Subject: AP1000 Response to Request for Additional Information (TR 85)

RAI-TR85-SEB1-02 R2

AP1000 TECHNICAL REPORT REVIEW

RAI Response Number: RAI-TR85-SEB1-02

Figure RAI-TR85-SEB1-02-1 - NI05 Model (from North-West)

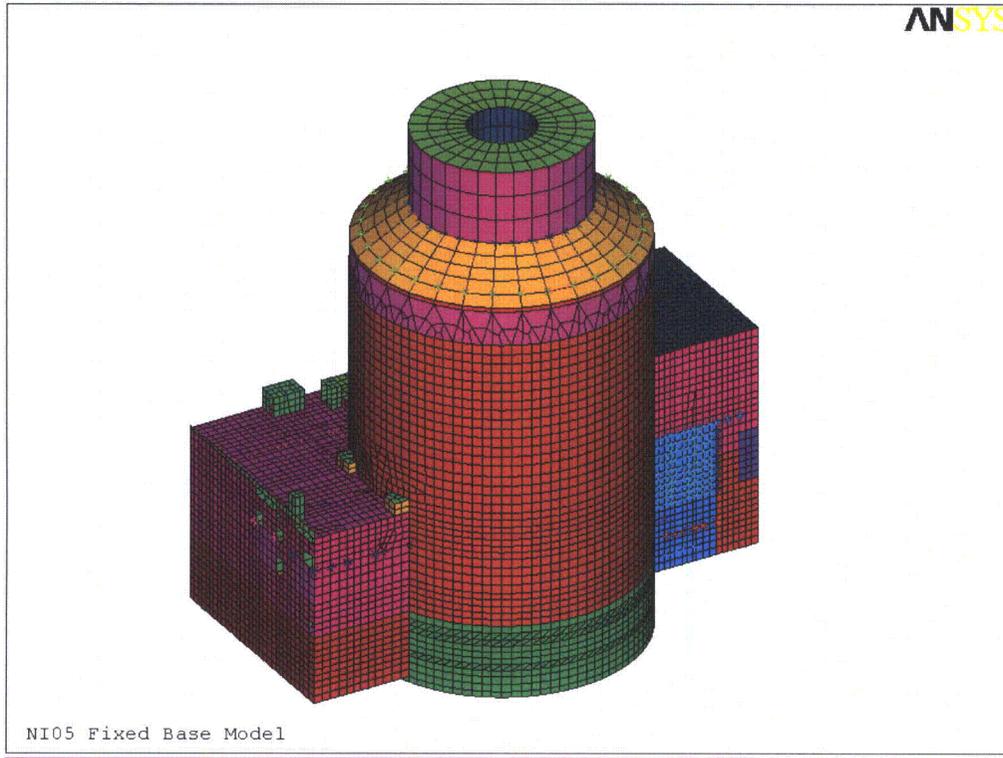
The staff reviewed the RAI response provided in Westinghouse letter dated 9/28/07, and noted that the response does not provide sufficient information. Westinghouse is requested to explain how the reactions on the side walls below grade were calculated (i.e., description of the analysis approach used to calculate the loadings for each of the lateral earth pressures listed in the RAI response), and how they were applied to the walls for design of the foundation walls and basemat (e.g., the calculated pressures applied to the overall 3D ANSYS finite element model [specify which model] and whether a linear elastic static analysis was used).

The analyses of the Nuclear Island for the lateral earth pressure loads are performed using 3D linear elastic ANSYS analysis. The NI05 model is used that is shown in Figure RAI-TR85-SEB1-02-1. The lateral earth pressure loads are applied to the finite element nodes associated with embedded Nuclear Island structural walls. The analysis performed is linear elastic. Loads and moments at the base of the exterior walls are extracted from NI05 analyses and are added in the design analyses of the basemat.

Figure RAI-TR85-SEB1-02-2A – Schematic Load Diagrams for Live, Earth and Dead Loads

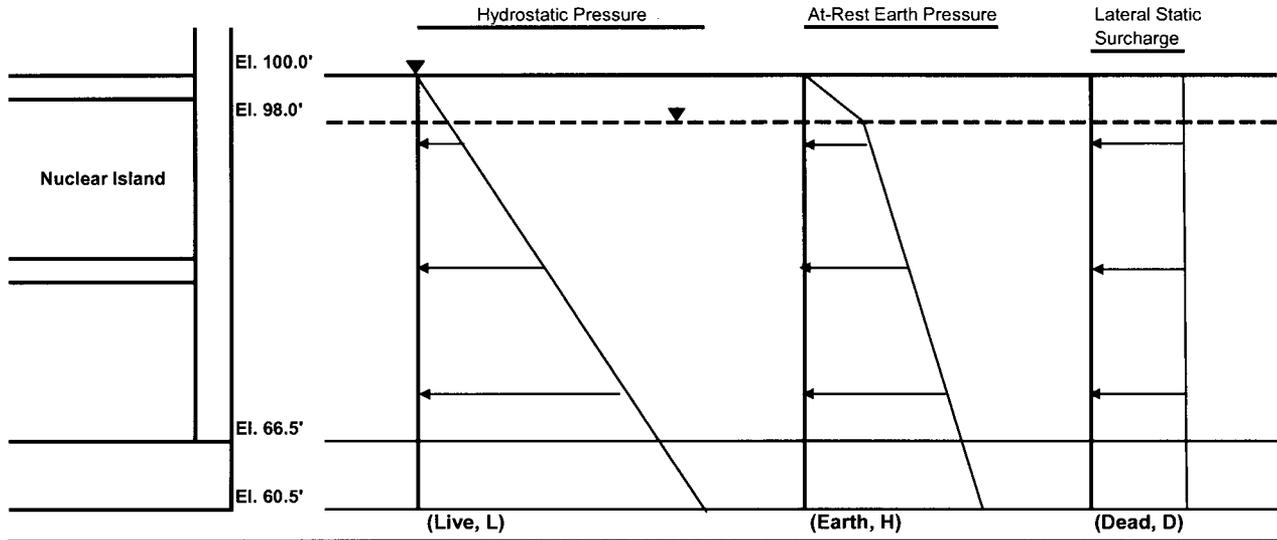
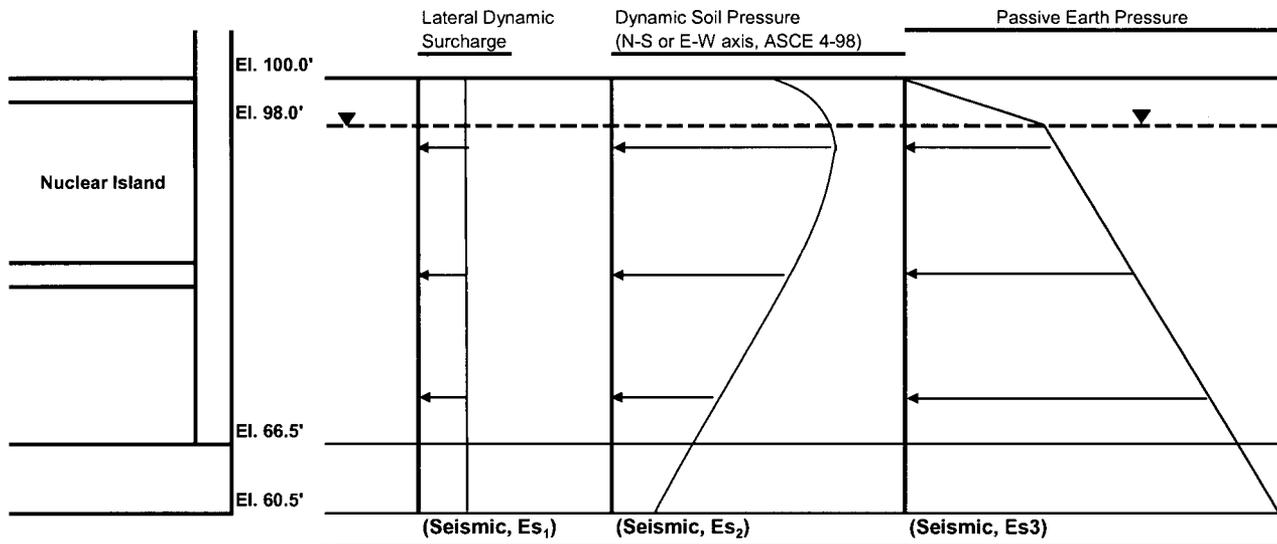
The RAI response provided a description of the reactions on the exterior walls below grade subjected to the various loads including lateral earth pressure loads. The analytical approach to calculate the pressure loads presented in the RAI response consisted of hydrostatic, at rest earth pressure, surcharge pressure, dynamic earth pressure, and passive earth pressure. In the case of seismic earth pressure loads, the approach was performed in accordance with ASCE 4-98, Section 3.5.3, which utilizes the elastic solution for dynamic soil pressures. In addition, the passive pressure loads needed to resist sliding during an SSE are also considered in the design of the exterior walls below grade. From the information provided it is not clear that lateral soil pressure loads, caused by vertical seismic loading of the soil, had been considered in the design of the foundation. In addition, the RAI response does not provide the vertical profile of lateral earth pressure loads on embedded walls from the 3D SASSI analyses, the ASCE approach, and the passive soil pressure loads used for the stability analyses, and how the walls were designed

(2) Provide the vertical profile of lateral earth pressure loads on embedded walls from each of the following analysis methods: 3D SASSI, ASCE approach, and the passive soil pressure load approach used for the foundation stability evaluation, and describe how the walls were designed from these vertical profiles of lateral earth pressure.

The design high ground water level is at Elevation 98'-0", and the probable maximum flood level is at Elevation 100'-0". Both of these loads are treated as live loads. The flood level of Elev. 100'-0" is represented in the Schematic Load Diagram in Figure RAI-TR85-SEB1-02-2A for use in plotting the load combination results presented in Figure RAI-TR85-SEB1-02-3. The hydrostatic unit water pressure (P_w) at a depth h (units: feet) below ground level is calculated as:

Figures RAI-TR85-SEB1-02-2A and -2B present schematic diagrams of the lateral pressures for the load conditions discussed above. These load conditions

Figure RAI-TR85-SEB1-02-4 – Seismic Effects on Lateral Soil Pressure

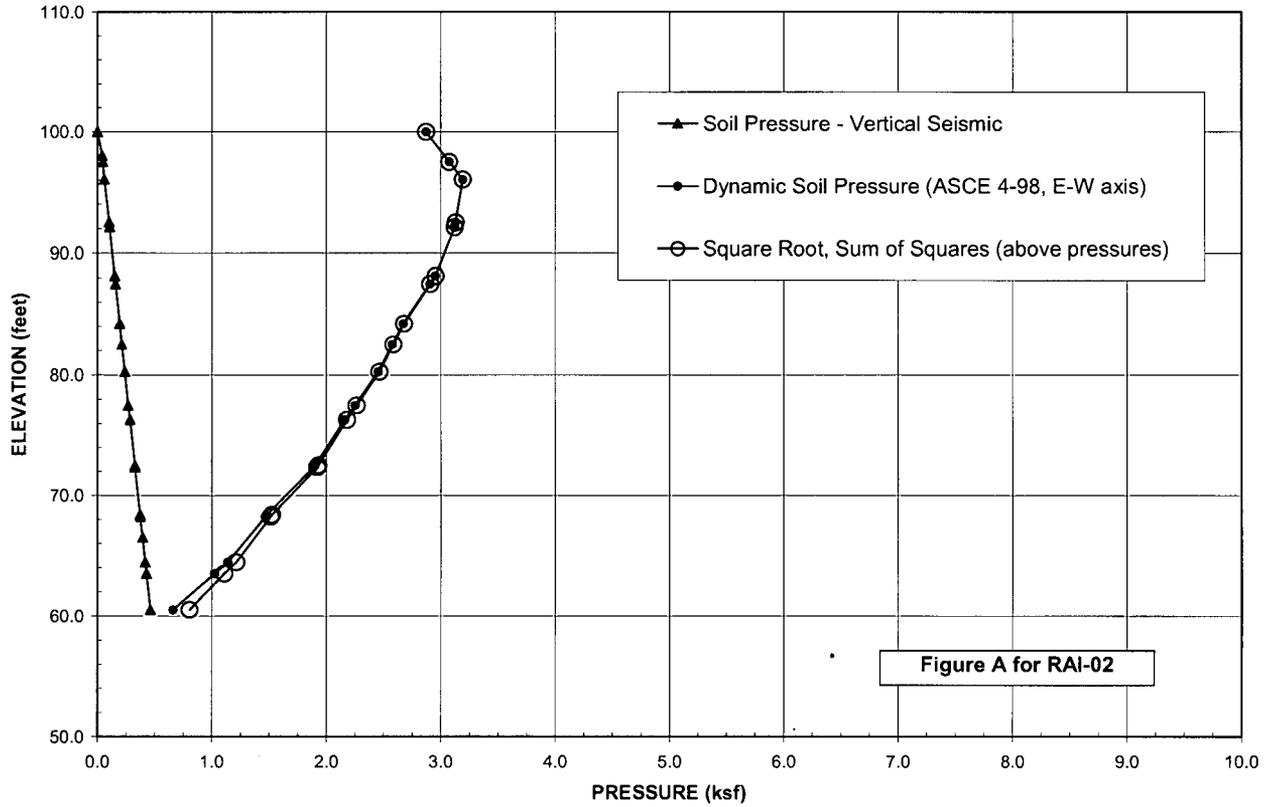
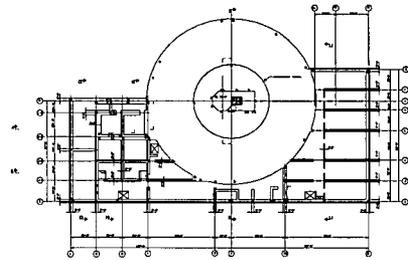
(1) Explain how the lateral soil pressure loads, caused by vertical seismic loading of the soil, were determined and how were they considered in the design of the foundation.

The graph of "Soil Pressure – Vertical Seismic" in Figure RAI-TR85-SEB1-02-4 presents the At-rest Earth Pressure (for the generic soil model or Case 15 Soil) multiplied by 0.3 (seismic acceleration factor). This same factor was used to determine the dynamic lateral surcharge pressure (Seismic, E_{s2}) noted above. These tabular values were combined with the values from the Dynamic Soil Pressure (along the East-West axis) by the SRSS Method (square root, sum of squares) and plotted against the Dynamic Soil Pressure (along the East-West axis) alone. As shown on the plot, the contribution of vertical seismic effect on the at-rest earth pressure is negligible to the Dynamic Soil Pressure plot. Therefore, vertical seismic effect is negligible and the Dynamic Soil Pressure alone was used in determining the load combination.
